UNITED STATES PATENT AND TRADEMARK OFFICE

APPLICATION NO.	FILING DATE	FIRST NAMED INVENTOR	ATTORNEY DOCKET NO.	CONFIRMATION NO.
10/815,855	04/02/2004	Marcellus Johannes Hubertus Raedts	2003-1008	9891
466	7590	09/18/2006	EXAMINER	
YOUNG & THOMPSON 745 SOUTH 23RD STREET 2ND FLOOR ARLINGTON, VA 22202			CECIL, TERRY K	
			ART UNIT	PAPER NUMBER
			1723

Office Action Summary

DETAILED ACTION

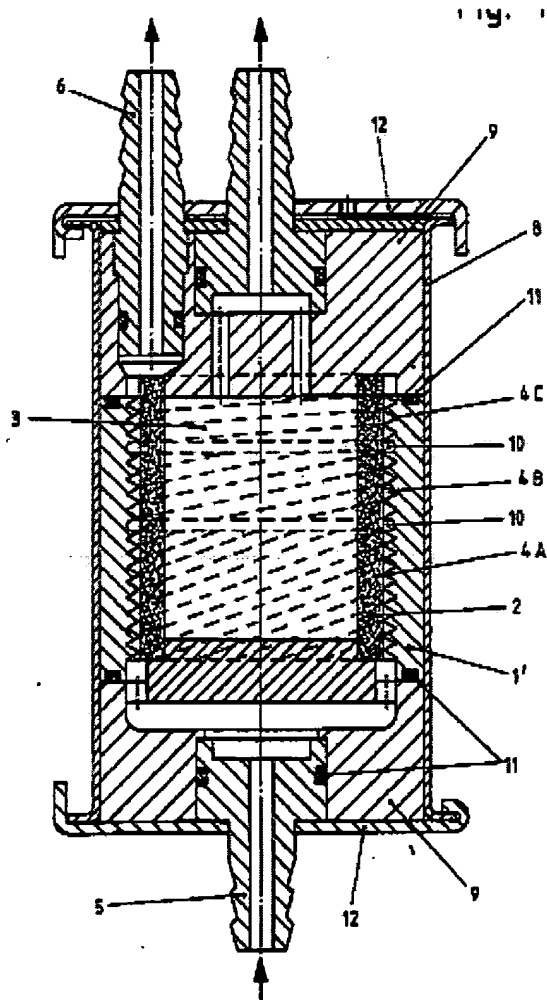
'196 teaches a filtration system having a flow that is from the outside in. The radially symmetry of the filter body and filter element is evident in the drawings [as in claim 1]. A second outlet 8 is provided for a tangential outlet flow [as in claim 2]. Liquid impermeable end caps 10, 11 are taught as well as the outlets 10, 11 and inlet 6 being opposite thereto [as in claim 11].

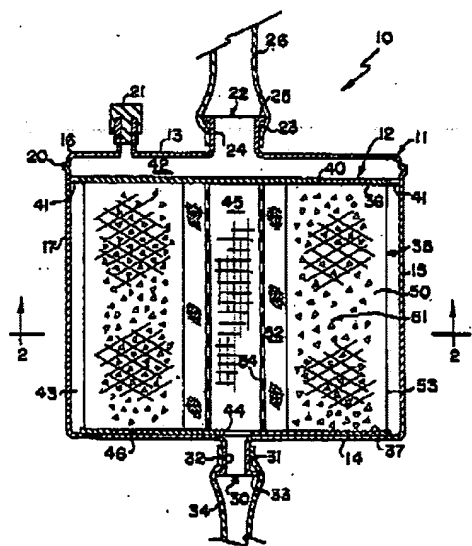
9. Claims 1-2 are rejected under 35 U.S.C. 102(b) as being clearly anticipated by EP 0239666, hereinafter '666.

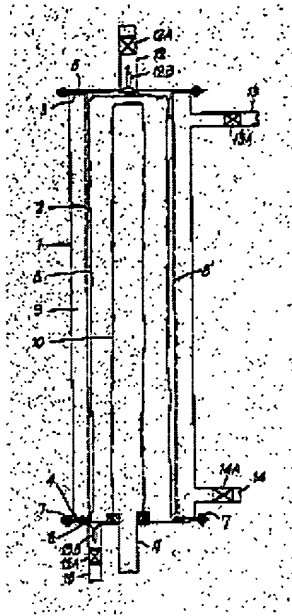
13. Claims 8-10 and 12-13 are rejected under 35 U.S.C. 103(a) as being unpatentable over '196 in view of Jewell, as applied above and in further view of EITHER FR 1,276,086, hereinafter '086 OR Gwilliam (U.S. 3,276,594). As explained above, Jewel teaches a matrix [as in claim 12]. The modified '196 doesn't teach a filler body. However, such is taught either '086 or Gwilliam as shown below [as in claims 8-10 and 12-13].

It is considered that it would have been obvious to one ordinarily skilled in the art at the time of the invention to have the filler body of either '086 OR Gwilliam within the filter element of the modified '666, since both references teach the benefit of a simple means for removing filter cake from the upstream side of a radial filter.
